SUBJECT: Coastal Texas Project Anchorage Area Discussion

Prepared By: Himangshu Das, Mike Diaz, & Paul Hamilton

Subject: RE: CTX Anchorage Area (Summary Draft and map)

Figure 3(a) – Proposed New Anchorage Area Footage by the Anchorage Working Group

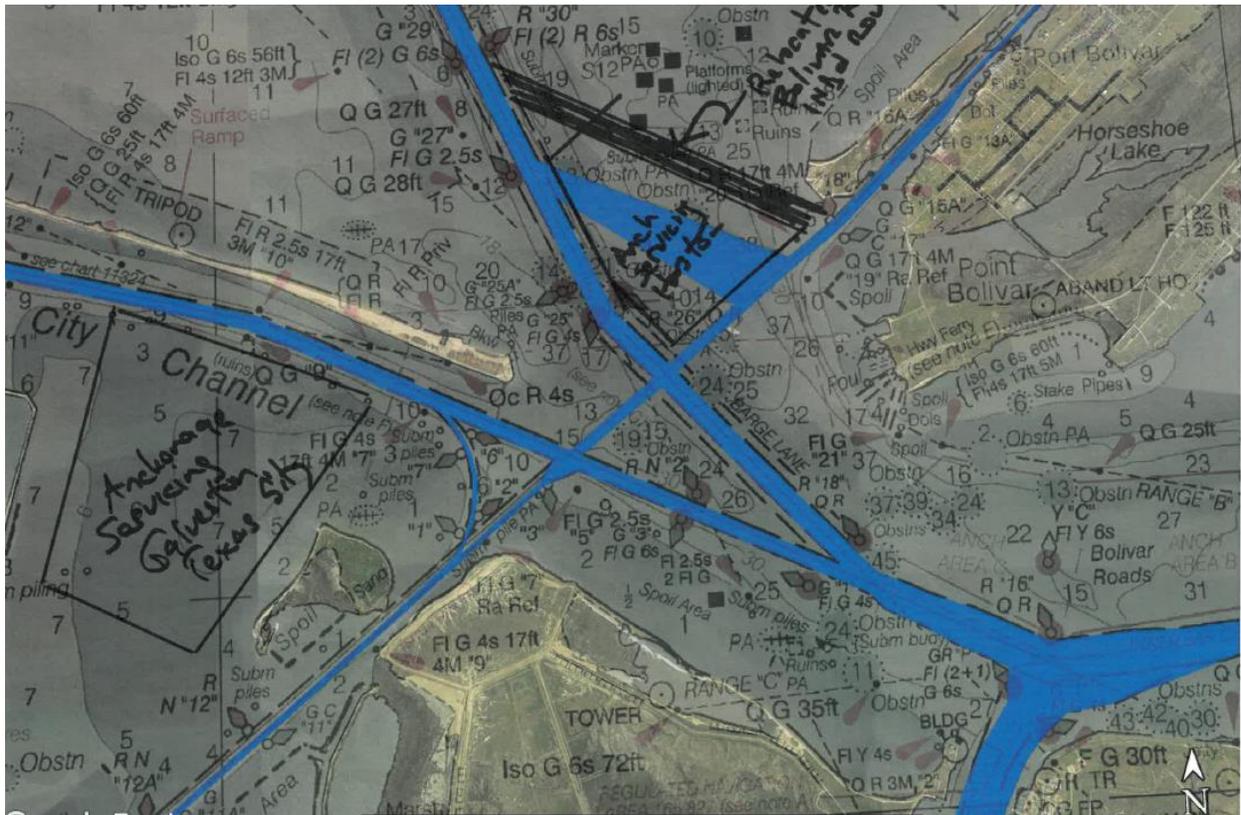
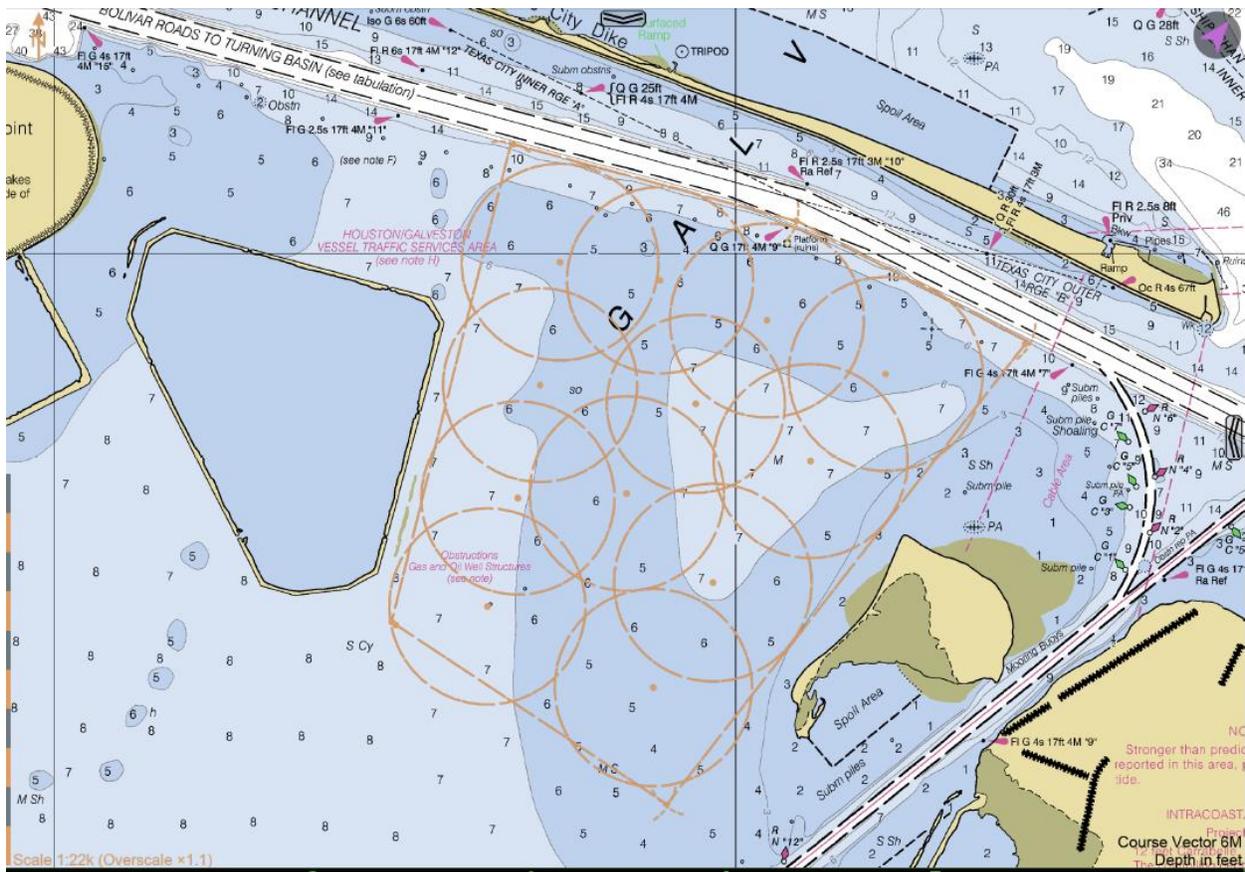
Proposed anchorage behind Pelican Island - has the potential for hypoxia issues. It also eliminates the ability to create enough obstruction to force water out Bolivar Roads and not into West Bay during wrap around in-bay hurricane wind driven surge. This anchorage will likely slowly fill with fine grained sediment.

Figure 6: Modified anchorage areas and surge barrier system across the entrance channel.

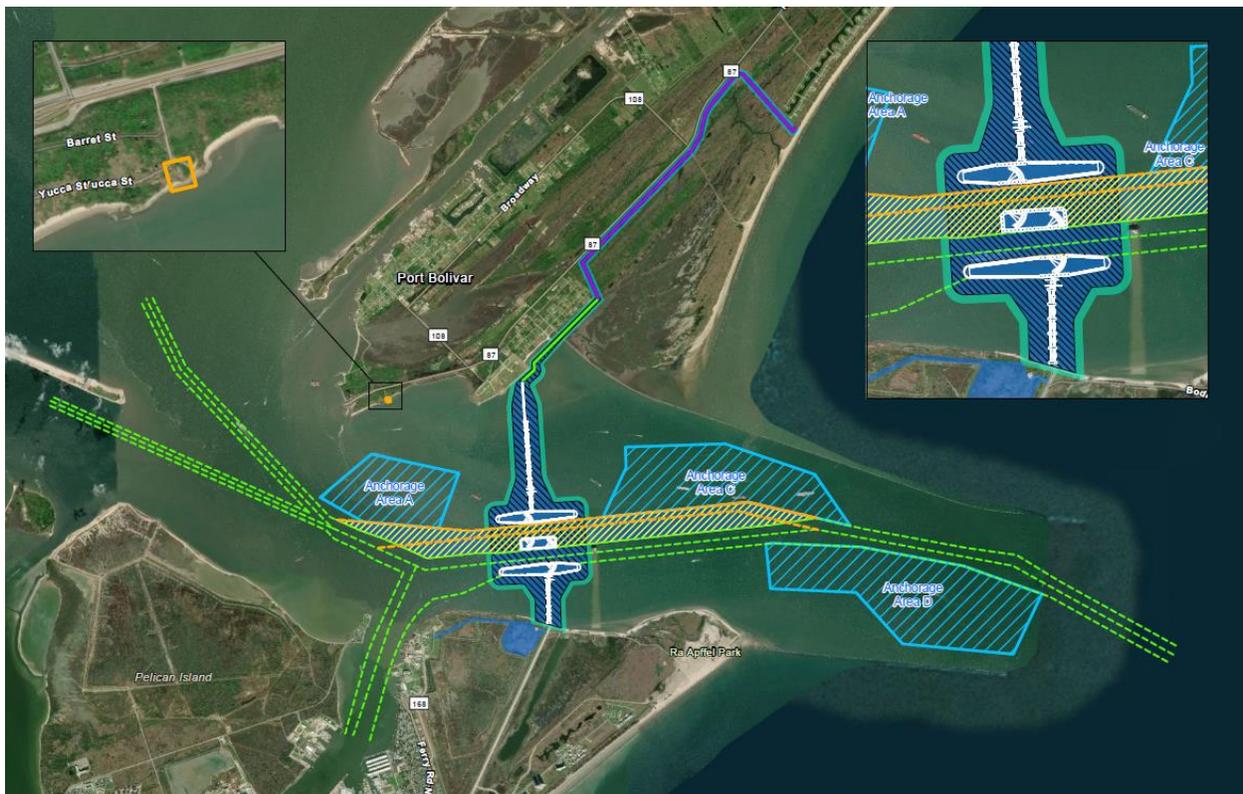
Proposed Anchorage servicing Houston (Bolivar Flare) - this location will increase conveyance through the Bolivar Roads inlet likely slightly offsetting losses in tidal prism from the Storm Surge Barrier's installation. It will have shoaling issues, however this is also a benefit as this material in this location is mostly sandy and will likely be suitable for beach placement, thus this area could also function as a sediment trap.

Anchorage Area 3 (D) - this location does not seem very sheltered at least on its outer extents, the sea state in this area will have to be modeled for its suitability for an anchorage.

Anchorage Area 5 - adding this anchorage area to the recommended plan seems valuable as the O&M will be likely minimal and its shelter location, adjacent to the Port of Galveston. It will likely require fixing moorings, however.

How were the anticipated shoaling rates determined for each of the anchorage areas? That is not discussed.
